CTA Standard

Updates to Dynamic HDR Metadata Signaling

CTA-861.4

March 2019

Figure 1 Extended InfoFrame Transmission Window and Metadata Applicability

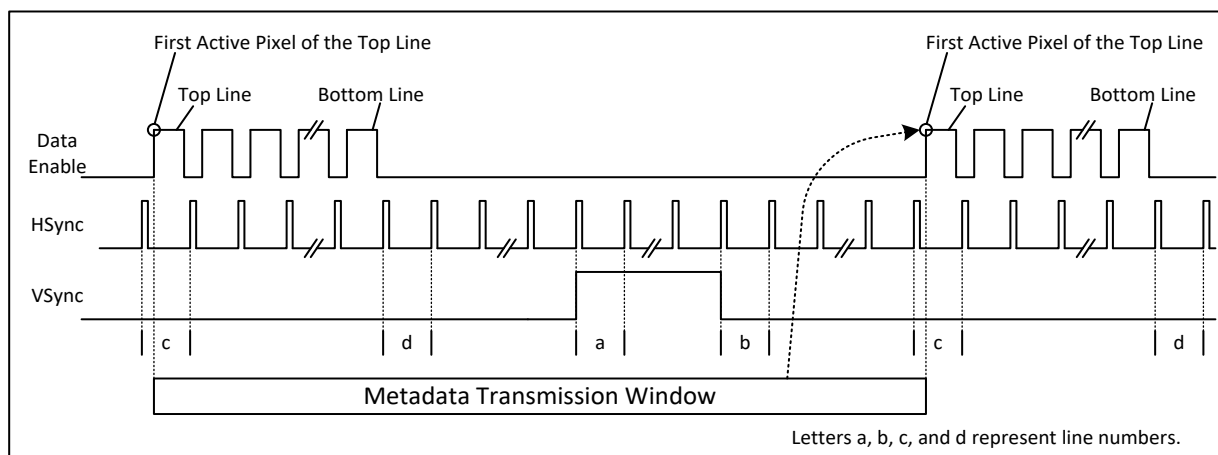
The second paragraph of Section 6.10.1 HDR Dynamic Metadata Extended InfoFrame and Figure 7 HDR Dynamic Metadata Transmission Window and Metadata Applicability of CTA-861-G [A] are moved to the end of Section 6.10 and modified, as shown below:

Figure 7 depicts the transfer timing and applicability of the Extended InfoFrame data relative to the video lines. The Metadata Transmission Window (MTW) is defined as the period of time beginning with the first Active Pixel of a Video Frame and ending with the final Blank Pixel of the final Blanking Line in a Vblank period. As shown by the arrow in Figure 7, an Extended InfoFrame transmitted during the MTW applies to the Active Pixels that immediately follow the MTW. Standards and specifications that incorporate CTA-861 may reduce the period of the MTW by delaying the start of the MTW and/or ending the MTW on an earlier Blanking Line.
